REF: L1661.2 V2

2<sup>nd</sup> July 2024

**RE: GLYNCORRWG INDUSTRIAL UNITS, NEATH PORT TALBOT  
STAGE 3 ACOUSTIC DESIGN REVIEW**

FIGURE 3: ACOUSTIC DESIGN INTENT FOR INTERNAL ELEMENTS

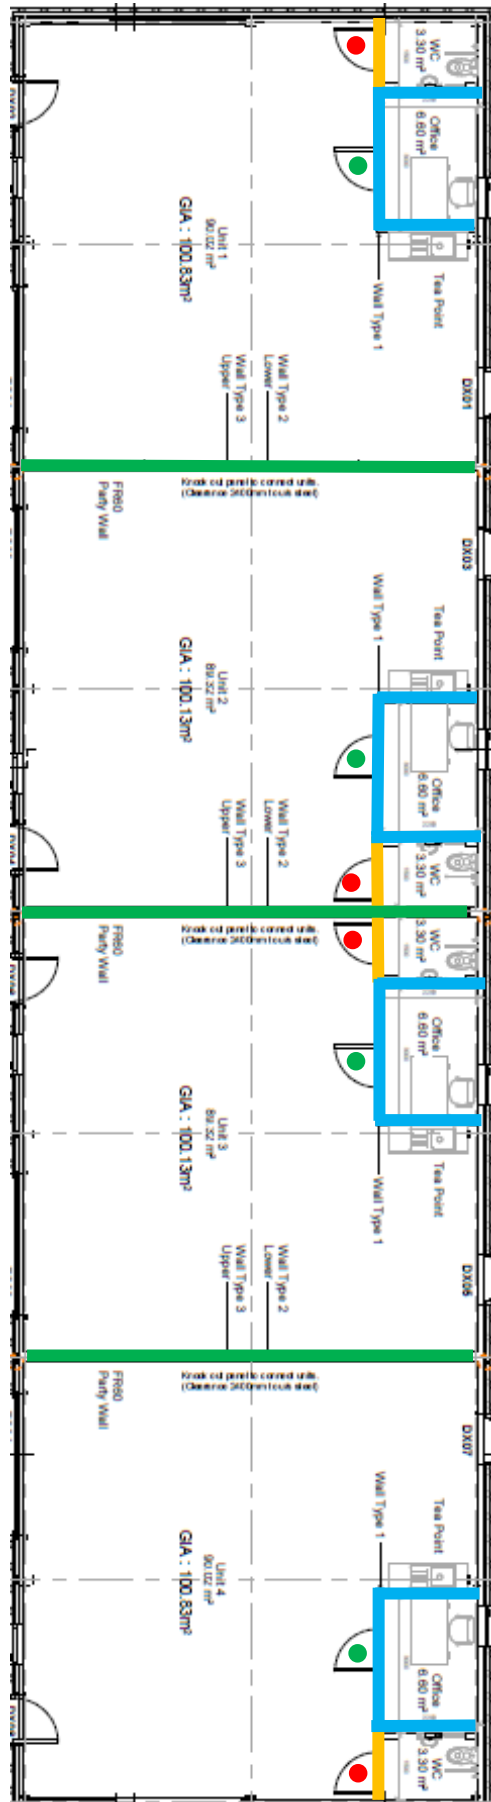
{Note 1} The separation between these rooms contains a connecting door. A door will limit the acoustic separation. To maintain a reasonable separation with a functional door we recommend these doors have an acoustic rating of at least 35 dB  $R_w$  and the wall a rating of a minimum 45 dB  $R_w$ .

We therefore recommend that additional absorption is included in the form of 35 m<sup>2</sup> of Class A wall panels. With the inclusion of such a provision, we expected the reverberation time in the workshop to be reduced to 1.5 s and therefore achieve the derived target levels.

We propose the doors in walls serving non-sensitive rooms (door Type 1) are procured with a laboratory tested performance of 30 dB R<sub>w</sub> to offer a reasonable balance between function and operability, with an upgraded door of 35 dB R<sub>w</sub> for doors which connect occupied rooms.

| Wall Type Ref. | Construction Description                                                                                                                | Min Laboratory Performance $R_w$ (dB) | Substantiation Reference |
| 1              | Gypframe 70 S 50 C studs at 600 mm cts, 1 x 15 mm Gyproc DuraLine board to both sides                                                   | 40                                    | Q606062                  |
| 2              | Gypframe 70 S 50 C studs at 600 mm cts, 1 x 15 mm Gyproc DuraLine board to both sides, 25 mm Modular Roll in the cavity                 | 45                                    | Q606063                  |
| 3              | Gypframe 70 S 50 C studs at 600 mm cts, 1 x 15 mm Gyproc DuraLine board to both sides, 80 mm Modular Roll in the cavity                 | 48                                    | Q606065                  |

| Door Type Ref | Dot Colour Key | Typical Construction Description                                                                                                                                     | Minimum Laboratory Performance $R_w$ (dB) |
|---------------|----------------|----------------------------------------------------------------------------------------------------------------------------------------------------------------------|-------------------------------------------|
| 1             | ●              | 30 dB $R_w$ laboratory tested riser door set, typically 45 mm solid core door set (door leaf mass of min 23 kg m <sup>-2</sup> ) with perimeter acoustic/smoke seals | 30                                        |
| 2             | ●              | 35 dB $R_w$ laboratory tested riser door set, typically 45 mm solid core door set (door leaf mass of min 38 kg m <sup>-2</sup> ) with perimeter acoustic/smoke seals | 35                                        |
